# UNITED STATES PATENT AND TRADEMARK OFFICE

APPLICATION NO.	FILING DATE	FIRST NAMED INVENTOR	ATTORNEY DOCKET NO.	CONFIRMATION NO.
10/020,937	12/19/2001	Dong June Kim	MRE-0047	2861

<b>Office Action Summary</b>	Application No. 10/020,937	Applicant(s) KIM, DONG JUNE	
	Examiner PAUL T. CHIN	Art Unit 3652

### DETAILED ACTION

## Exhibit A

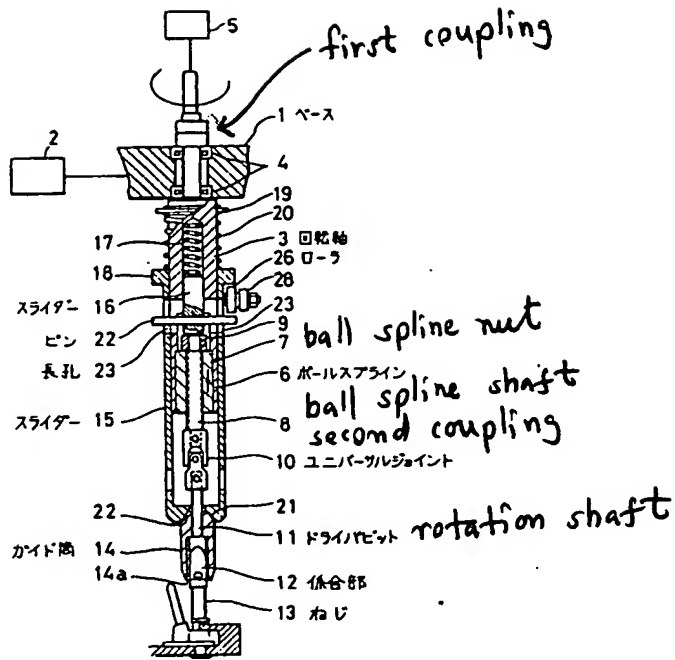
The Japanese Patent (JP 63-162129) discloses a device comprising a rotation unit, or a motor (5) configured for generating a rotary force and transmitting the rotatory force; a ball spline unit (7,8) configured for performing a rotation movement and a vertical reciprocation movement by the rotary force generated from the motor; a rotation shaft unit comprising a rotation shaft (11), wherein the rotation shaft unit is configured to be moved in a vertical direction and rotated for mounting part (13); and a plurality of couplings (see Exhibit A) configured for transmitting the rotary force of the rotation

Re claims 2 and 6, the Japanese Patent (JP 63-162129) shows a first coupling (see Exhibit A, Figs. 1 and 2) for connecting the motor to a first end portion of the ball spline unit, and a second coupling (10), a universal joint, for connecting a second end portion of the ball spline unit (8) to the rotation shaft unit (11).

Re claims 3 and 12, the first coupling is connected between the motor and the ball spline nut (Fig. 1).

Re claim 10, figure 1 of the Japanese Patent clearly shows the first end of the ball spline unit comprises a ball spline nut (7) and the second end of the ball spline unit comprises a splined shaft (8). It is pointed out that the Japanese Patent device discloses all the structural limitations and is configured or capable of performing the recited functional limitations.
